CNL Responses to Federal and Provincial Comments on the Draft Environmental Impact Statement for the Near Surface Disposal Facility Project

- Table 1: *Consolidated Table of Federal and Provincial Comments on the Draft Environmental Impact Statement for the Near Surface Disposal Facility Project, [232-509220-055-000](#), Revision 2, 2020 December.*
(See Pages 3 – 196)

Table 1: *Consolidated Table of Federal and Provincial Comments on the Draft Environmental Impact Statement for the Near Surface Disposal Facility Project, [232-509220-055-000](#), Revision 2, 2020 December.*

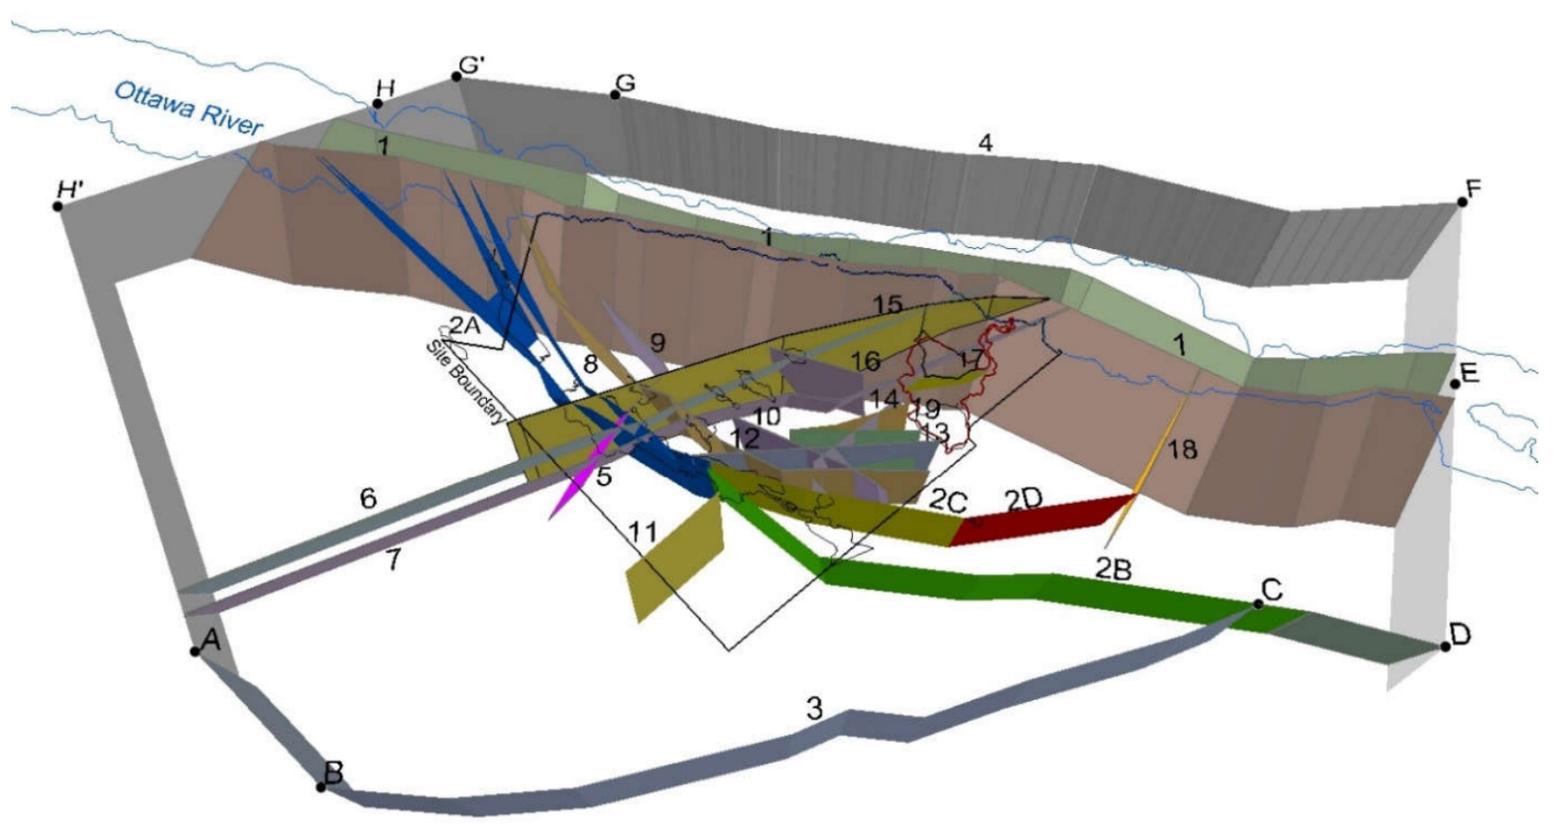
Reference #	Link to IR#1 (Original IR package)	EIS Section	Information Request & Response	Documents Impacted by the Response to IR			Accepted/ Rejected with request for follow-up information
				Document Name	Section/Figure/ Table Impacted by Response	Scope of New Information	
			<p>Context: Inconsistent information with respect to the construction of the ECM berm is provided in the revised EIS.</p> <p>Rationale: On page 3-32, it is stated that all overburden material will be removed in the area beneath the ECM berm, and the berm will be constructed on bedrock. However, figure 3.4.1-1 shows that a soil layer named "silty sand imp" directly underlines the berm</p> <hr/> <p>CNL Response</p> <p>CNL confirms that the statement on page 3-32 is correct, all overburden material will be removed in the area beneath the ECM berm, and the berm will be constructed on bedrock.</p> <p>A design change was made to ensure no liquefaction will take place as described on page 3-41 of the EIS. The design change involved removing the identified liquefiable soils underlying the berm and replacing the soils (down to bedrock) with compacted engineered granular</p>

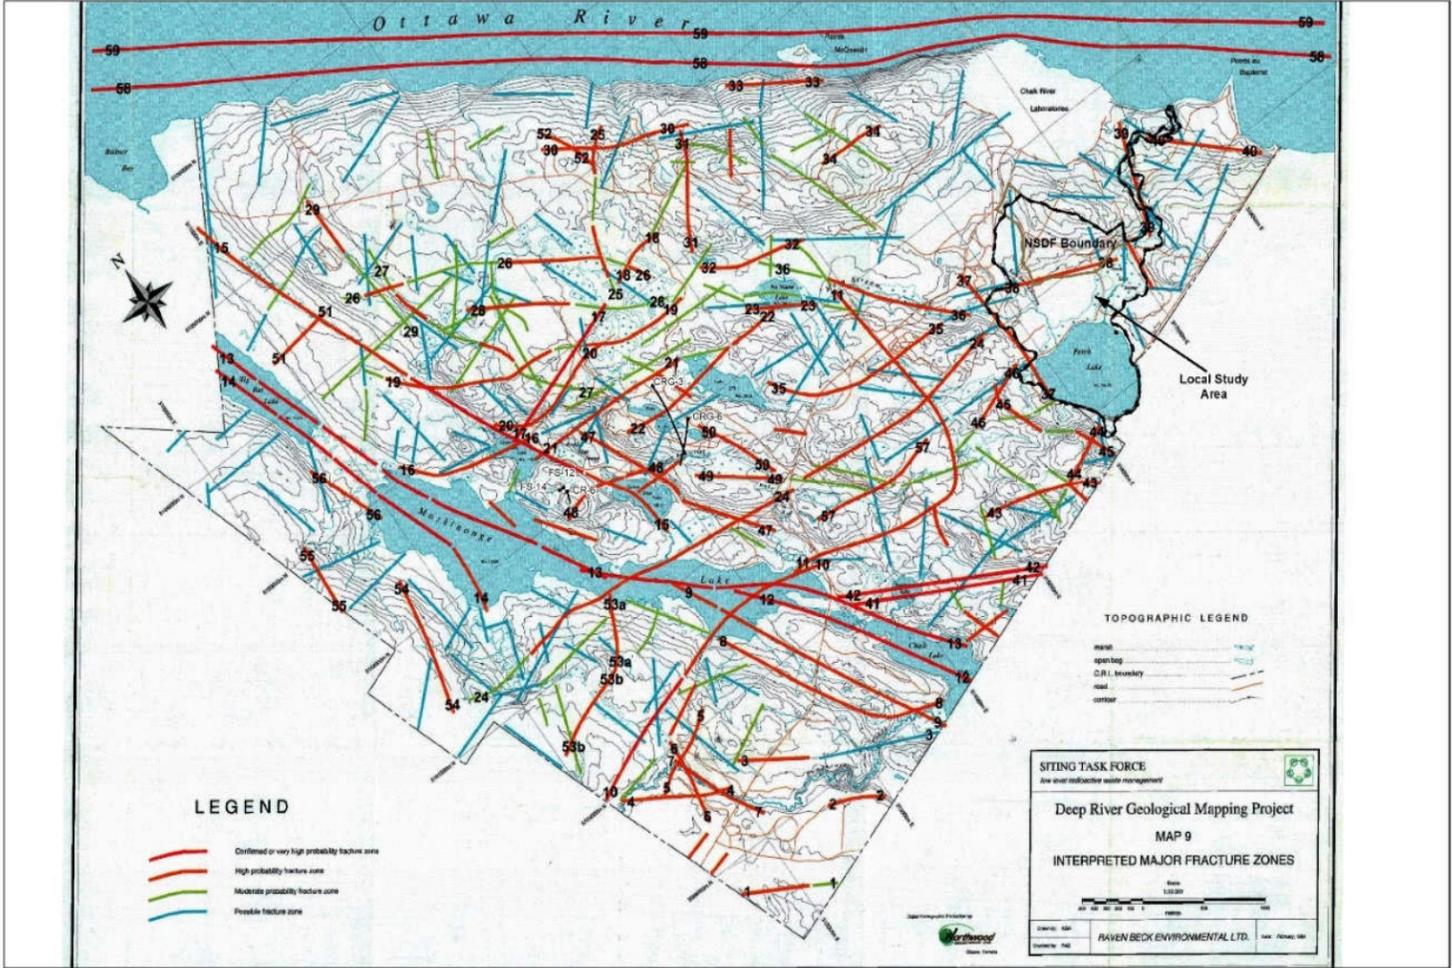
CNSC-2-10	New IR	Section 5.3	<p>Agency Information Request - Change to an environmental component due to radiological contaminants</p> <p>Question: The background information in section 5.3 of the revised EIS should be completed to accurately reflect the information in the supporting references (particularly the Geological Waste Management Facility Integrated Geosynthesis Report, including but not limited to #1 – 3 in Context section). The hydrogeology model should consider the structural data known for the site. Please demonstrate how a fractured bedrock surface will impact the analysis of the geological and hydrogeological VCs. Furthermore, considering the 10,000 year PostSA assessment time frame, the baseline information from the site that is relevant for the NSDF extends to the upper bedrock. The relevant baseline information must be clearly summarized in the EIS, and integrated into the predictive models of the site's future evolution.</p> <p>Context: Section 5.3 is incomplete. Geological features as documented in (for example) the Geological Waste Management Facility Integrated Geosynthesis Report (the Geosynthesis Report), which forms part of the reference information used to support the revised EIS, presents</p>	EIS	Section 5.3.1.4.2.1 (Regional Geological Conditions)	Updated to include a description of the two dykes and the fracture zones as described in historical data sources, including the Geologic Waste Management Facility (GWMF) Integrated	Rejected with Follow Up IR CNSC-3-02

EIS	Section 5.3.1.4.2.4 (Local and Site Area Geological Conditions)	Updated to include a description of Feature #17 as described in historical data sources, including the Geologic Waste Management Facility (GWMF) Integrated Geosynthesis (IG) report [1]
